Access Compliance Report

Public Rights-of-Way

(Curb Ramps)

Intersection ID: 13099	Main Street: S_MCDOWELL_ST	Cross Street: ELIZABETH_AV	Location: S
ADA ID: 4DD34A6DD317	Ramp Type: Para	Initial Pass/Fail: Fail	Overall Compliance: No
Severity Score: 12.5			
Codes/Mitigation Info/Possible Solution		Field Measurements/Component Compliance

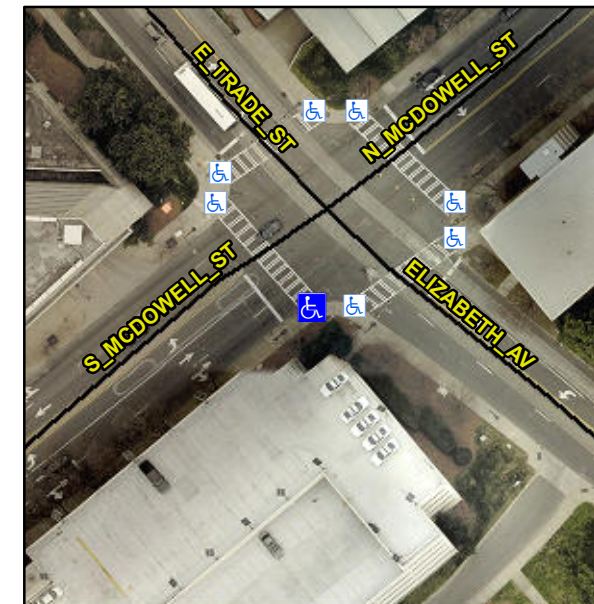
R304.5.1, R304.3.2, R304.5.3

Compliance	Description	Data	Compliance	Description	Data
N/A	Ramp Length LT (in)	47.0	N/A	Ramp Length RT (in)	N/A
Yes	Ramp Width LT (in)	82.0	No	Ramp Width RT (in)	N/A
No	Ramp Slope LT (%)	9.7	Yes	Ramp Slope RT (%)	1.5
Yes	Ramp XSlope LT (%)	0.6	No	Ramp XSlope RT (%)	N/A
N/A	Landing Length (in)	N/A	N/A	DWS Provided?	N/A
N/A	Landing Width (in)	N/A	N/A	DWS Contrast?	N/A
N/A	Landing Slope (%)	N/A	N/A	DWS Length (in)	N/A
N/A	Landing X Slope (%)	N/A	N/A	DWS Full Width?	N/A
N/A	Landing Curb? (Y/N)	N/A	N/A	DWS Offset (in)	N/A
N/A	Shared Landing?	N/A			
N/A	Gutter Ponding?	N/A	N/A	Gutter Slope (%)	N/A
N/A	Gutter Lip Ht (in)	N/A	N/A	Gutter X Slope (%)	N/A
N/A	Painted X Walk1?	Yes	N/A	Painted X Walk2?	N/A
	X Walk 1 Direction	To NW		X Walk 2 Direction	N/A
N/A	X Walk 1 Width (in)	112.0	N/A	X Walk 2 Width (in)	N/A
	X Walk 1 Slope (%)	1.2		X Walk 2 Slope (%)	N/A
	X Walk 1 X Slope (%)	1.7		X Walk 2 X Slope (%)	N/A
N/A	Ramp inside XWalk1?	Yes	N/A	Ramp inside XWalk2?	N/A

Remove & Replace Entire Ramp.
